Pentium® Pro Processor Specification Update

Release Date: March 1998

Order Number: 242689-026

1. *Mixing Steppings in MP Systems*

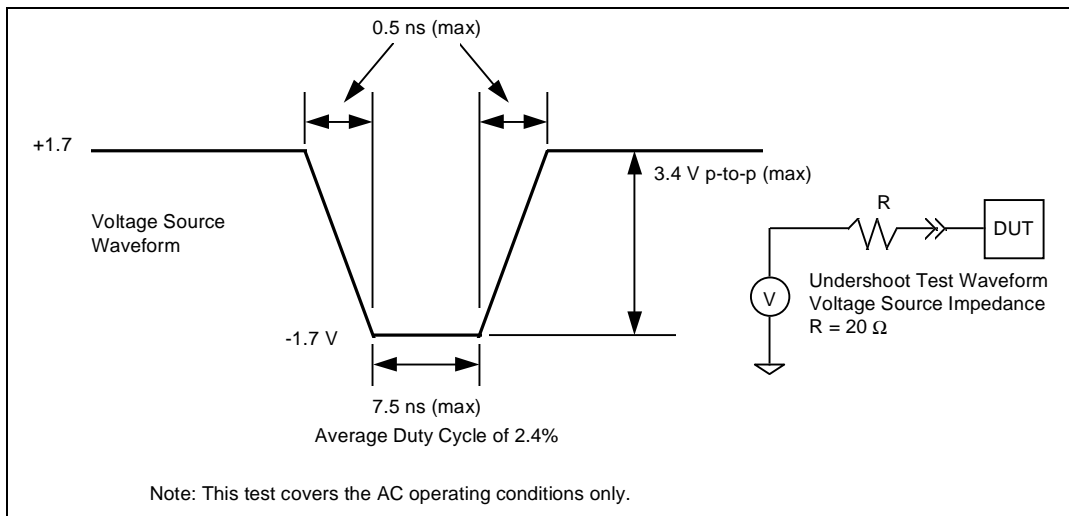
- While Intel has done nothing to prevent different frequency Pentium® Pro processors within a system from working together, there may be uncharacterized errata which exist in such configurations. In mixed stepping systems, all processors must be run at an identical frequency (i.e., the **highest** frequency acceptable to all components).

- The workarounds for various errata must take all processors into account.
- Errata for all processor steppings present in a system will affect that system, unless worked around.

- The following notes apply only to specific combinations:
 1. The 150-MHz and the 166-, 180-, and 200-MHz parts vary in their GTL+ T_{CO_MIN} and T_{HOLD} timings by 250 ps. This may affect some system designs. Also, a customer may wish to use a higher frequency replacement for a 150-MHz processor in a 150-MHz system; this should also be considered.

In the following table, "NI" implies that there are currently no known issues associated with mixing these steppings. An "X" implies that these steppings should not be used together in a system. A number indicates a known issue, and refers to the numbered list above. There are no currently known issues associated with mixing cache sizes.

Pentium® Pro Processor Stepping	150-MHz B0	150-MHz C0	166-, 180-, 200-MHz sA0	166-, 180-, 200-MHz sA1	166-, 180-, 200-MHz sB1	OverDrive® Processor
150-MHz B0	3	3	1, 3	1, 3	1, 3	X
150-MHz C0	3	3	1, 3	1, 3	1, 3	X
166-, 180-, 200-MHz sA0	1, 3	1, 3	3	3	3	X
166-, 180-, 200-MHz sA1	1, 3	1, 3	3	NI	NI	X
166-, 180-, 200-MHz sB1	1, 3	1, 3	3	NI	NI	X
OverDrive® Processor	X	X	X	X	X	2

ACTUAL vs. EXPECTED RESPONSE

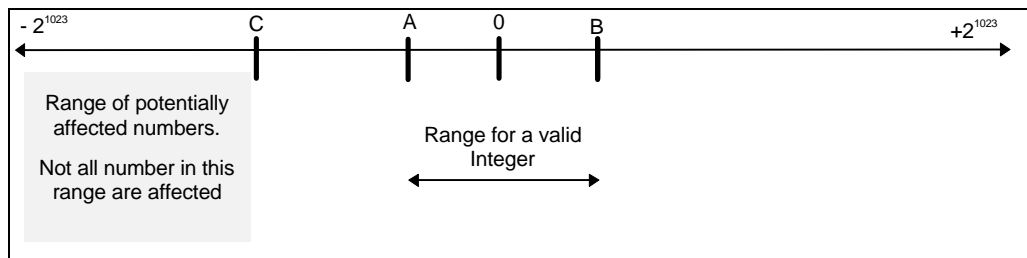
PROBLEM: On certain, large, negative, floating-point operands, and only in three of the four possible processor rounding modes, the instructions FIST[P] m16int and FIST[P] m32int do not detect that the operand is so large that it will not fit into the target data size. As a consequence, the expected Invalid Operation exception response for this

A. Actual Response:

When the required conditions are encountered, the processor provides the following response:

- Return the MAXNEG value (8000h for FIST16 & 80000000h for FIST32) to memory.
- The IE (Invalid Operation) bit in the Floating Point status word is *not set* to flag the use of an invalid operand.
- The PE (precision error) bit the Floating Point status word is *set*.
- No exception handler is invoked.
- In the case of a FISTP instruction the Operand will have been popped from the floating-point stack.

B. Expected Response

The expected processor response when the invalid operation exception is *masked* is:

- Return the MAXNEG value (8000h for FIST16 & 80000000h for FIST32) to memory.
- The IE (Invalid Operation) bit in the Floating Point status word is *set* to flag the overflow.
- The PE (precision error) bit the Floating Point status word is *not set*.

Figure 4-3. Stack Switch on a Call to a Different Privilege Level

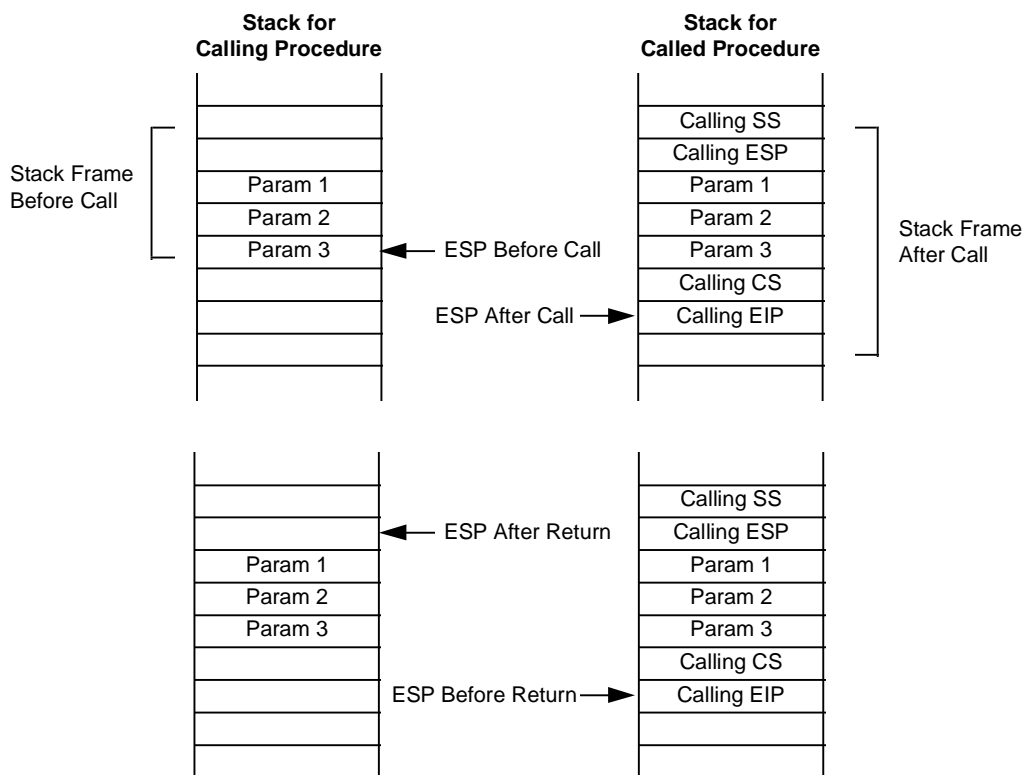
When making a call to a more privileged protection level, the processor does the following (see Figure 4-3):

6. Pushes the temporarily saved CS and EIP values for the calling procedure to the new stack.
7. Loads the segment selector for the new code segment and the new instruction pointer from the call gate into the CS and EIP registers, respectively.

8. Begins execution of the called procedure at the new privilege level.

When executing a return from the privileged procedure, the processor performs these actions:

1. Performs a privilege check.
2. Restores the CS and EIP registers to their values prior to the call.
3. (If the RET instruction has an optional n argument.) Increments the stack pointer by the number of bytes specified with the n operand to release parameters from the stack. If the call gate descriptor specifies that one or more parameters be copied from one stack to the other, a RET n instruction must be used to release the

parameters from both stacks. Here, the *n* operand specifies the number of bytes occupied on each stack by the parameters. On a return, the processor increments ESP by *n* for each stack to step over (effectively remove) these parameters from the stacks.

4. Restores the SS and ESP registers to their values prior to the call, which causes a switch back to the stack of the calling procedure.
5. (If the RET instruction has an optional *n* argument.) Increments the stack pointer by the number of bytes specified with the *n* operand to release parameters from the stack (see explanation in step 3).
6. Resumes execution of the calling procedure.

Note: On a return, parameters are released on both stacks if the correct value is given for the *n* operand in the RET *n* instruction.

Figure 4-4. Stack Usage on Transfers to Interrupt and Exception Handling Routines

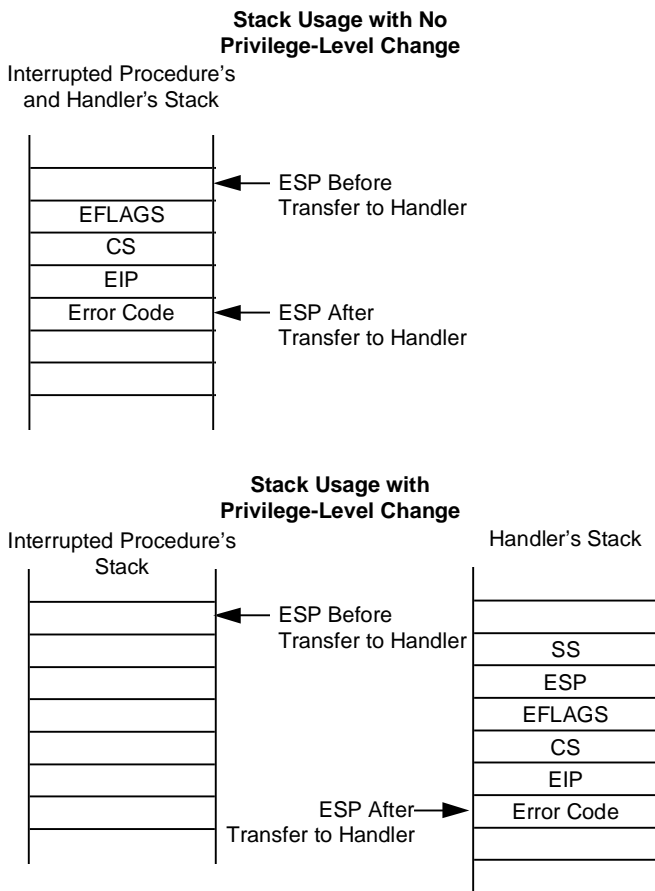
If no stack switch occurs, the processor does the following when calling an interrupt or exception handler (see Figure 44):

When executing a return from an interrupt or exception handler from a different privilege level than the interrupted procedure, the processor performs these actions:

1. Performs a privilege check.
2. Restores the CS and EIP registers to their values prior to the interrupt or exception.
3. Restores the EFLAGS register.
4. Restores the SS and ESP registers to their values prior to the interrupt or exception, resulting in a stack switch back to the stack of the interrupted procedure.
5. Resumes execution of the interrupted procedure.
